SUBJECT: Forwards response to NRC 801215 questions re SEP Topic IV-2, reactivity control sys. Design features which limit reactivity insertion rates & rod malfunctions from single failure described.

Subject: SEP Topic IV-2, Reactivity Control Systems  
R. E. Ginna Nuclear Power Plant  
Docket No. 50-244

## Response to SEP Topic IV-2 Questions

Figure 4-31. Power Cabinet, Schematic Diagram 1051E05  
(Sheet 2 of 14)

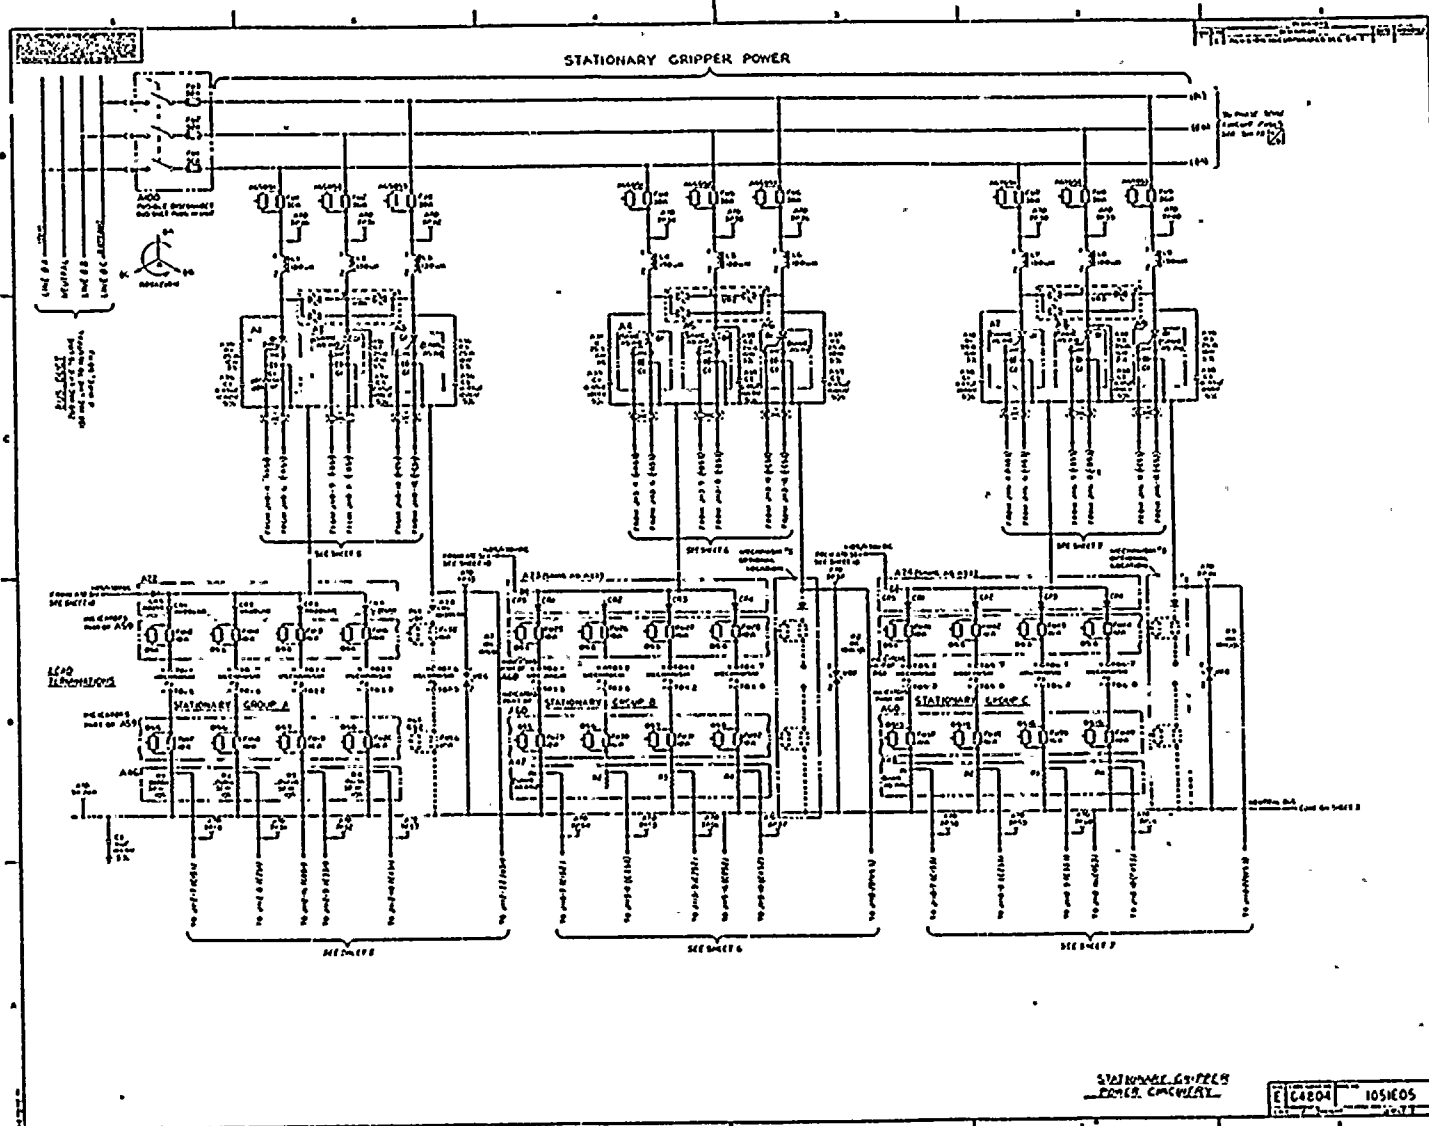
1. Any card not in place - each card has an interlock circuit associated with the Urgent Alarm.
2. An abnormal change in phase or current returning from the coils (Ripple detector 1051E05 sheet 2 & 10).
3. Coil current remaining saturated too long (E Sat. Detector 1051E05 sh. 2).
4. Firing circuit error (1051E05 sh. 11 & 12).
5. Multiplexing error (1051E05 sh. 12).
6. Logic Error (1051E05 sh. 12).

**Figure 4-31. Power Cabinet, Schematic Diagram 1051E05  
(Sheet 10 of 14)**

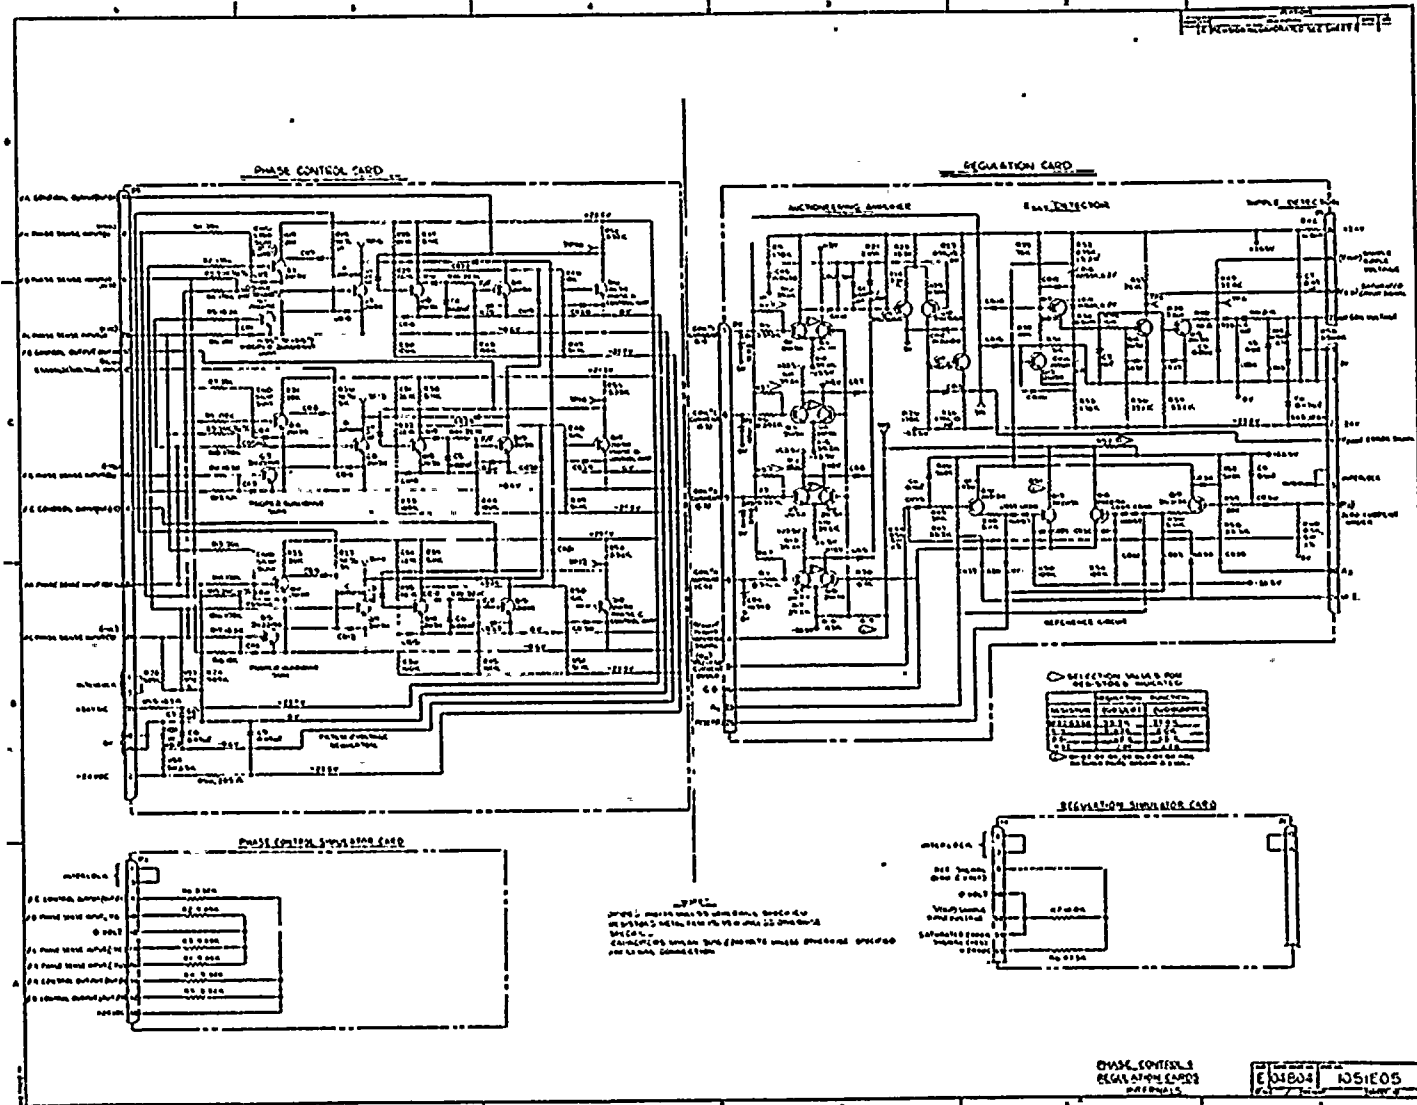
1. Signal AL-1 is generated and commands reduced power to the Stationary and Movable Gripper Regulation Cards (1051E05 sh. 9 & 12).
2. Signal AL-3 is generated and commands zero current on Lift Regulator Card (1051E05 sh. 10 & 12).

Figure 4-68. Logic Cabinet, Logic Flow, Maximum System 6056D01 (Sheet 2 of 15)

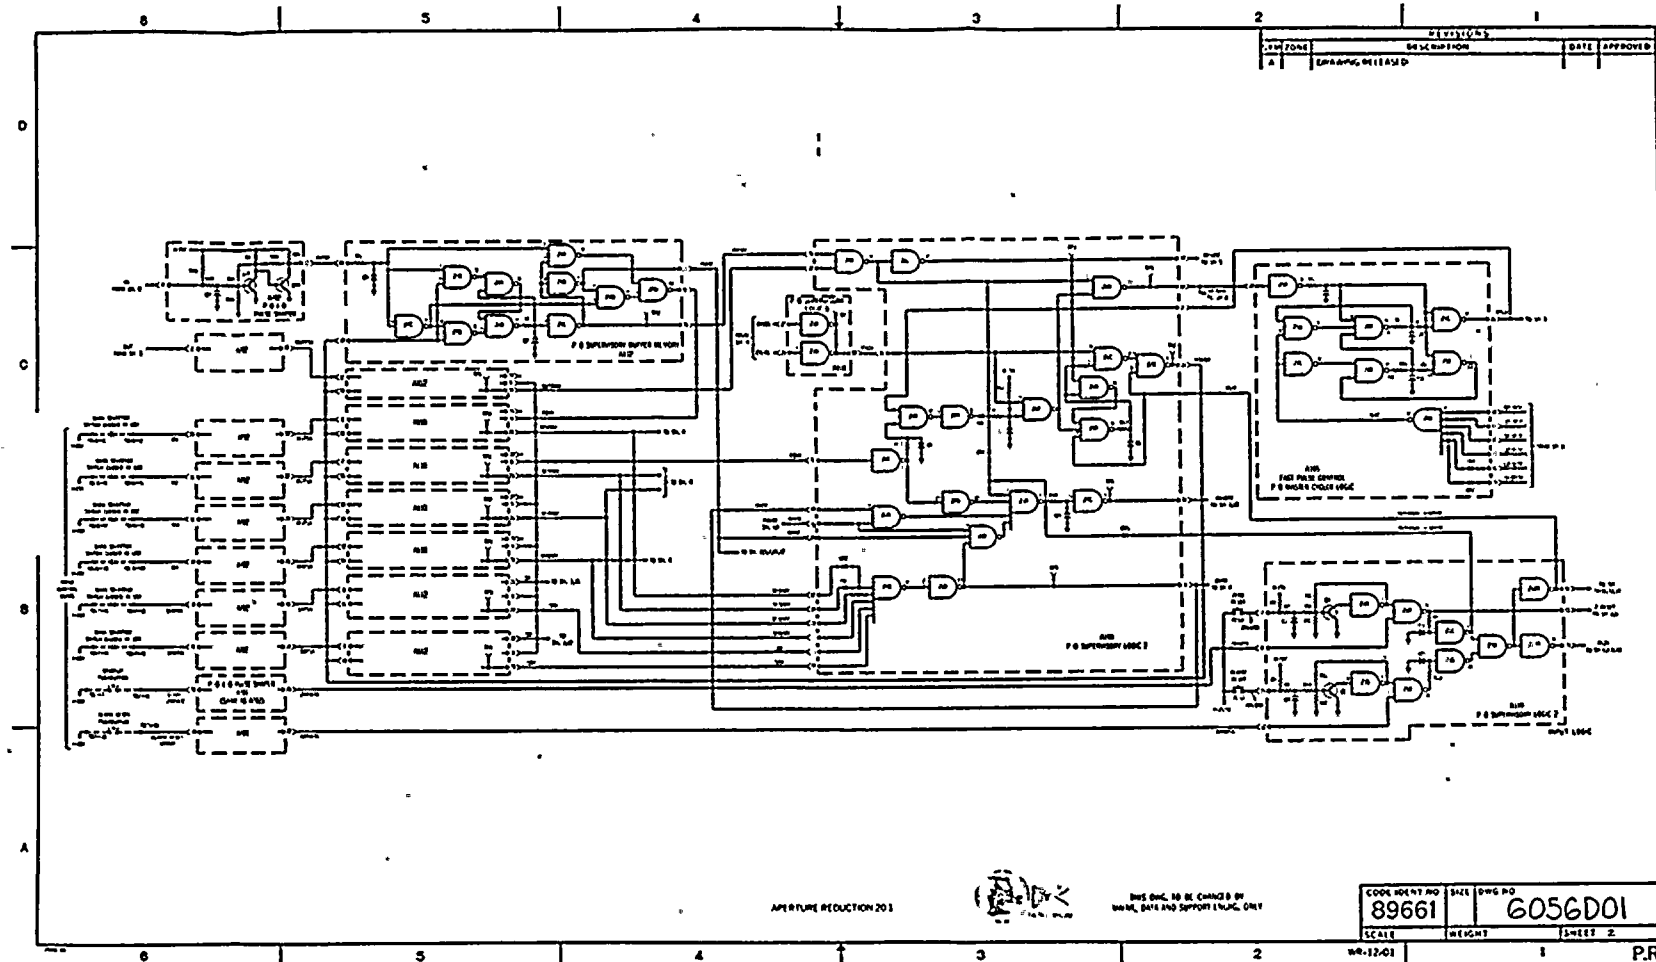
Rod positioning is controlled by the bank overlap unit (6056D01 sh. 2 & 4). This unit keeps track of rods that move and rods to be moved sending a signal to the power cabinets. Thumb wheel switches with two diodes per switch per digit control bank overlap.

Figure 1-6. L-106 Rod Control Drive Mechanism, Timing Diagram

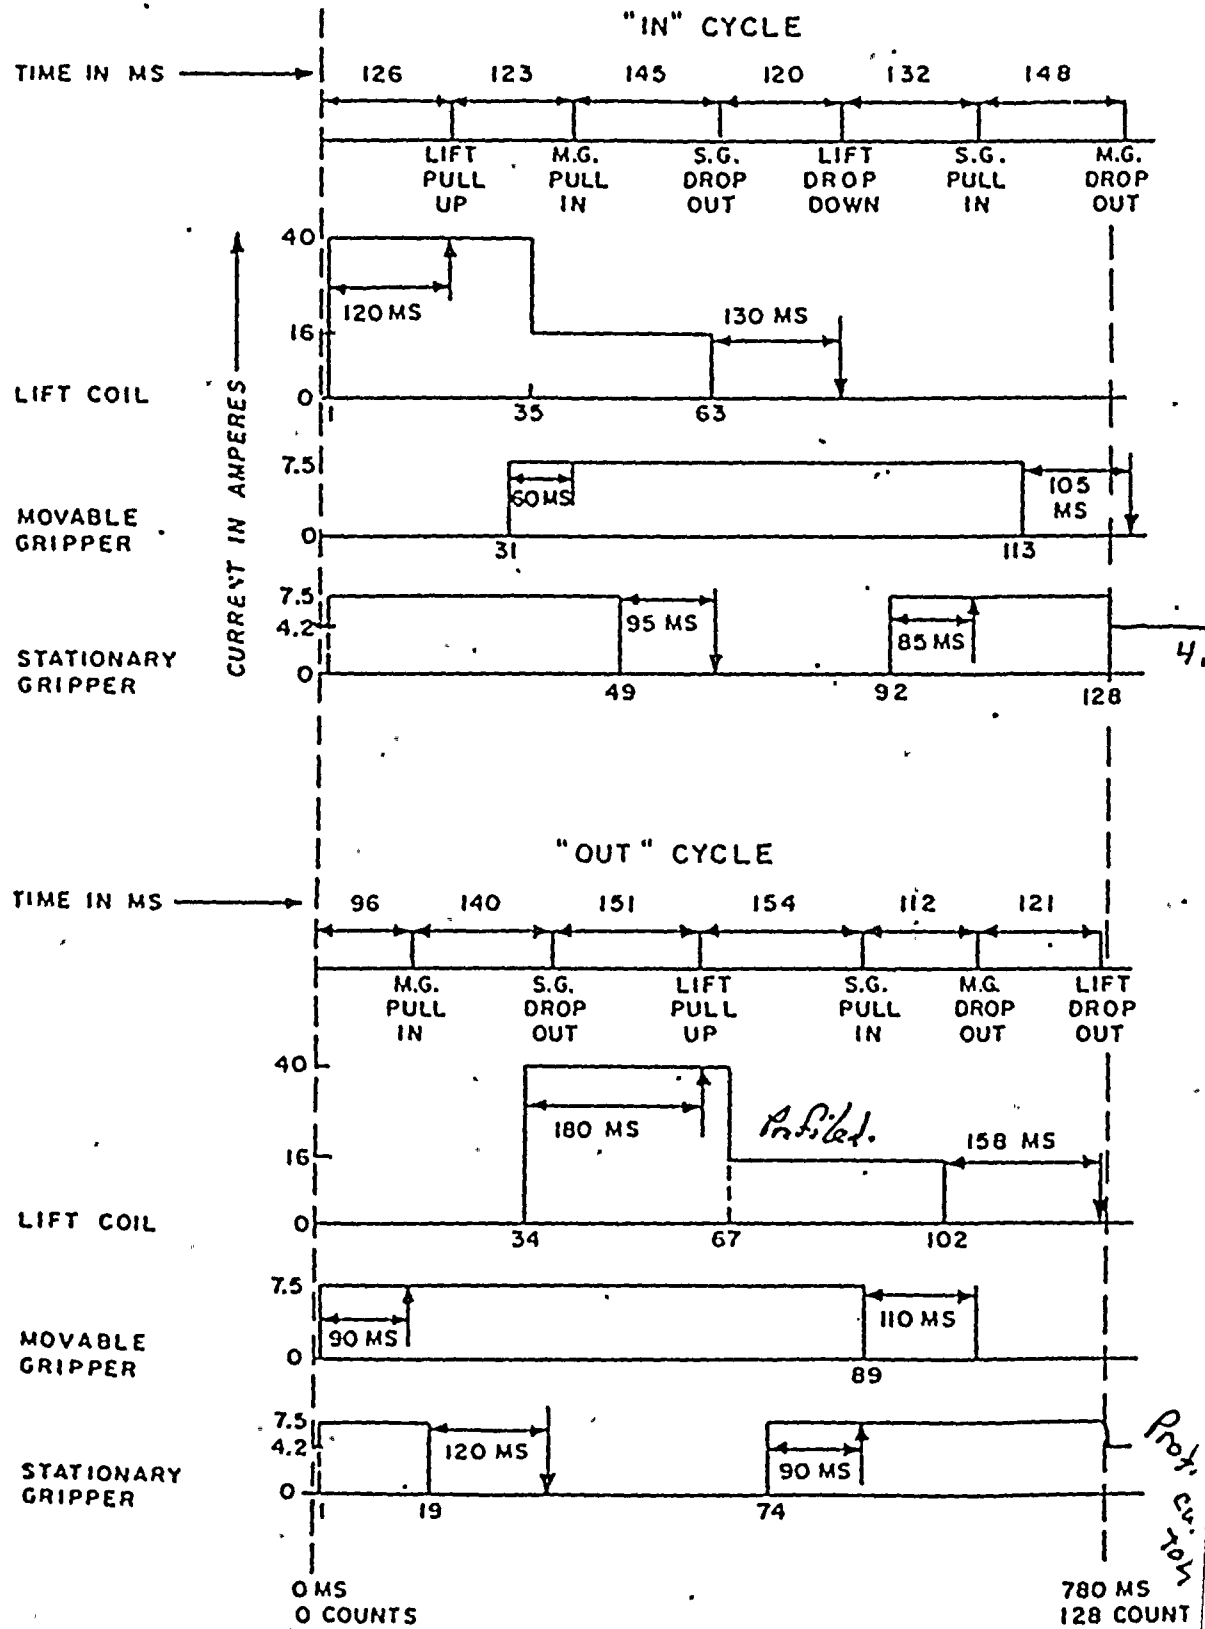
Another feature which limits the reactivity insertion rate is the manner by which rod speed is controlled. A buffer memory accepts a command go signal. Another go signal is inhibited until a slave cycler finishes. (6056D01 sh. 4 and Figure 1-6).
